**SUNDRY NOTICES AND REPORTS ON WELLS**

MCA Unit #101

30-025-08043

- ☒ Abandonment  
☐ Recompletion  
☐ Plugging Back  
☐ Casing Repair  
☐ Altering Casing  
☐ Other  
☐ Change of Plans  
☐ New Construction  
☐ Non-Routine Fracturing  
☐ Water Shut-Off  
☐ Conversion to Injection  
☐ Dispose Water

PROPOSED

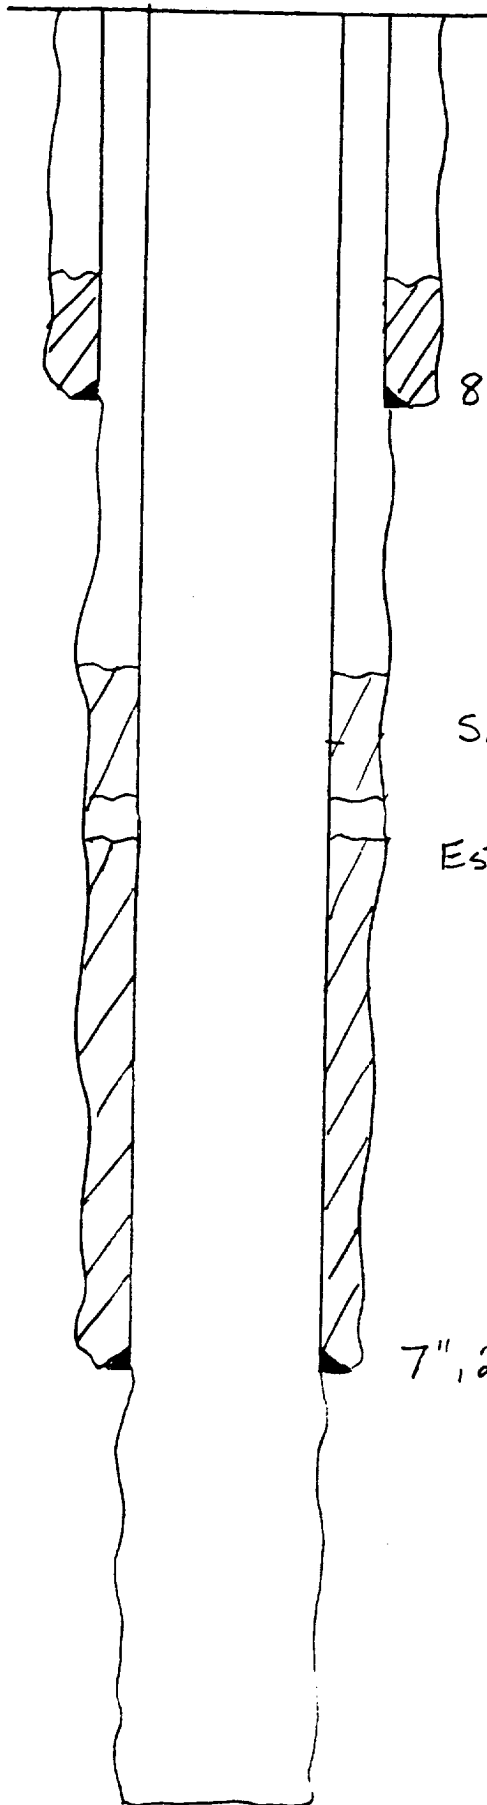
See attached. Also tag plug @ 8 5/8" csg shoe.
